IDAHO WATER RESOURCE BOARD

ITB 2021-002 Mile Post 31 Embankment Project Q & A

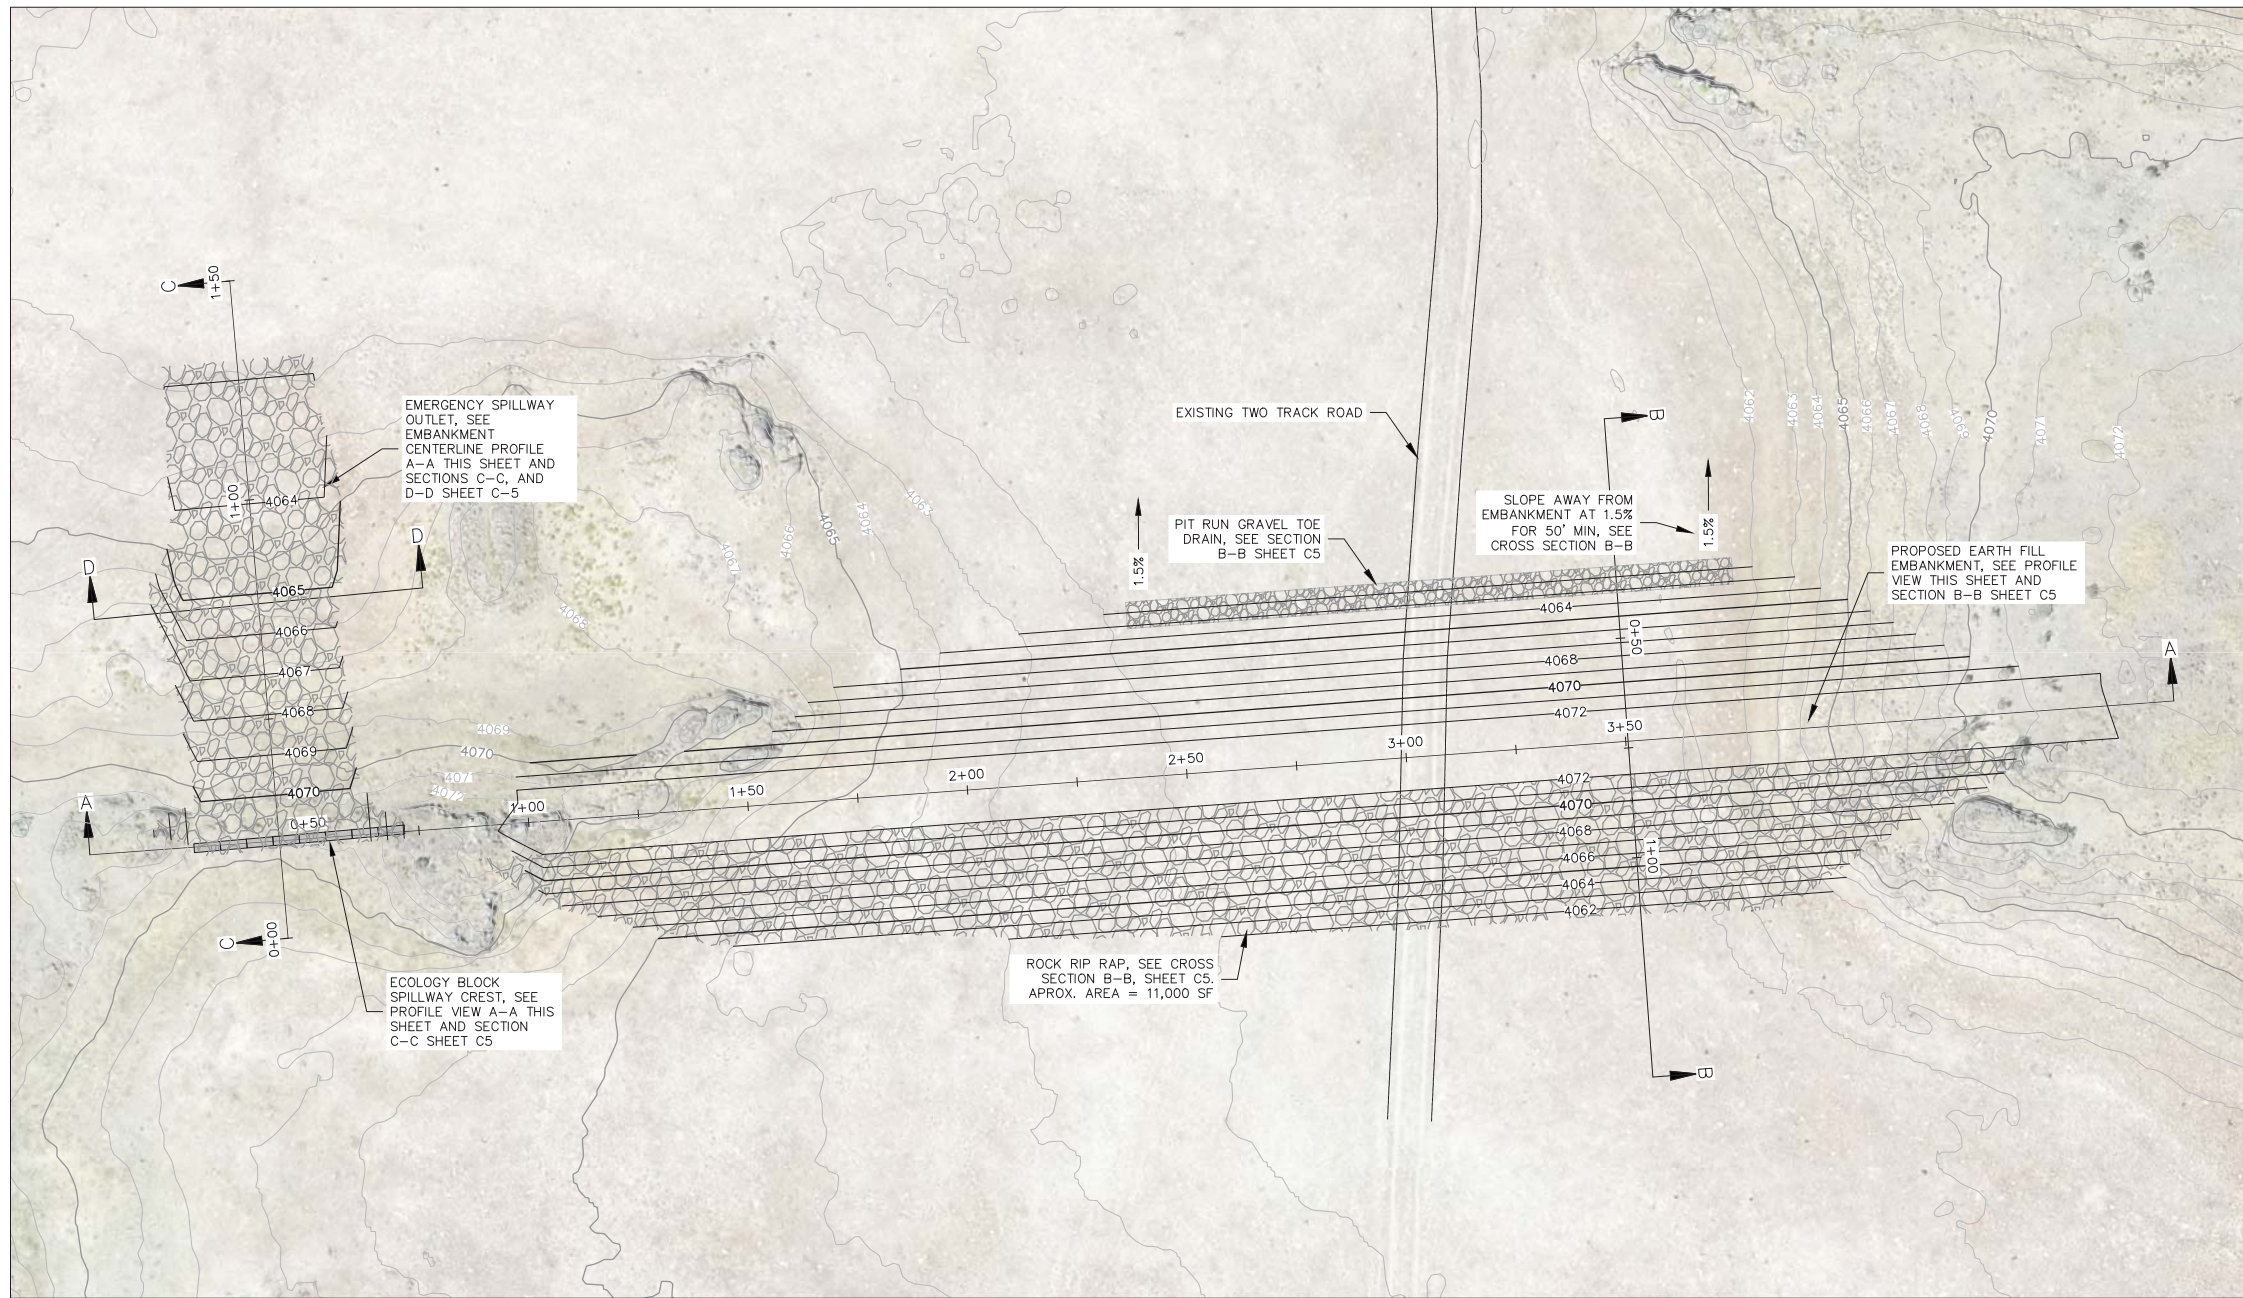
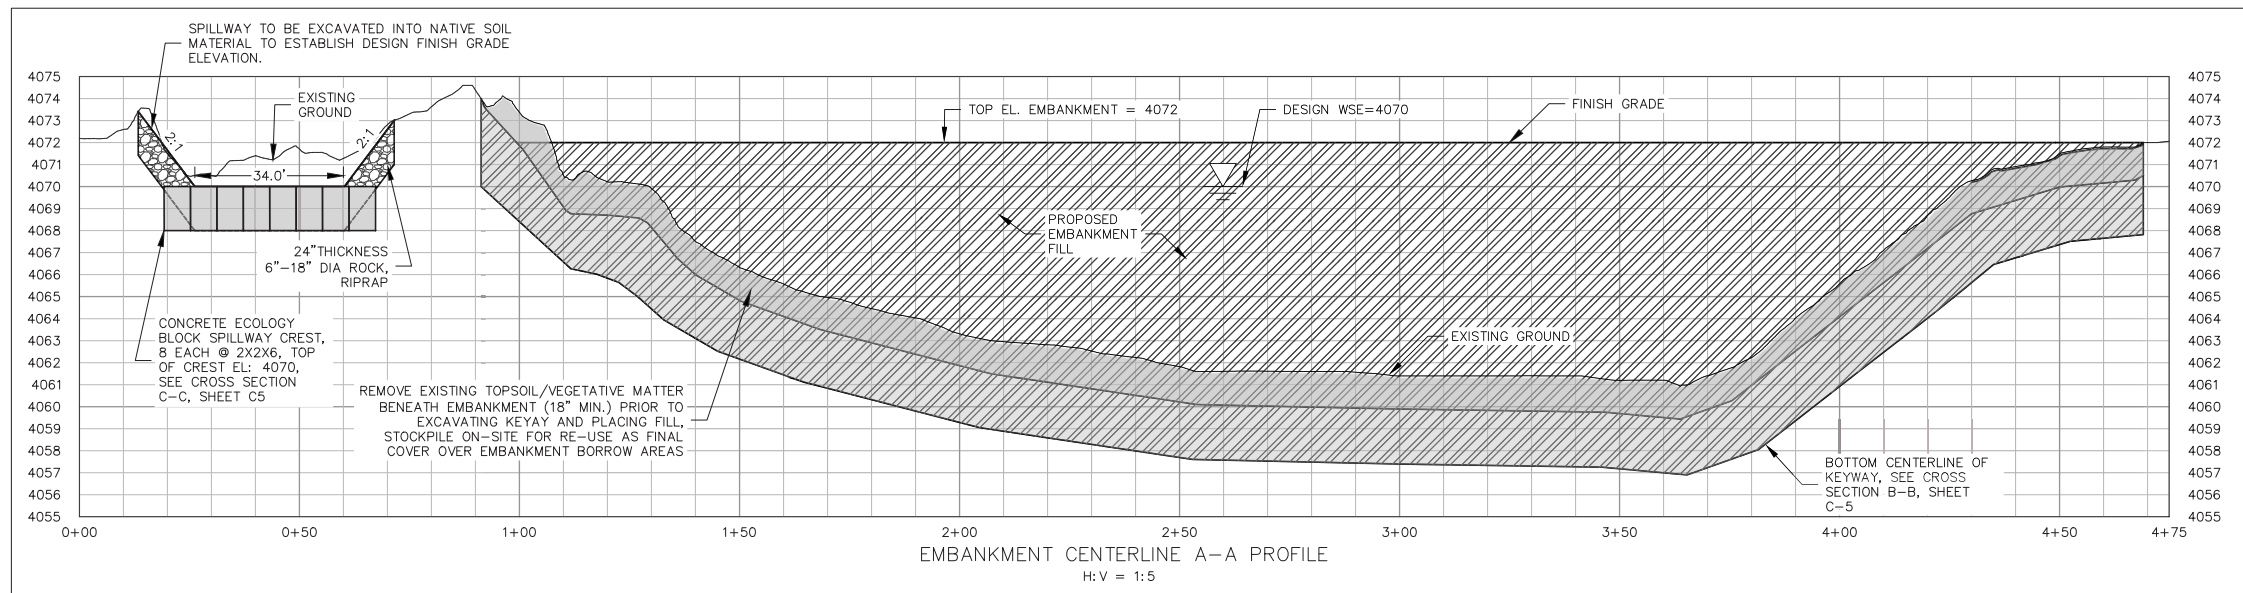
-
- 1. Can you please provide labeling for the existing contours on the east side of plan sheet C4?**

An updated Sheet C4 showing existing ground contours east of the embankment is provided with this response. Plan sheet C4 attached.
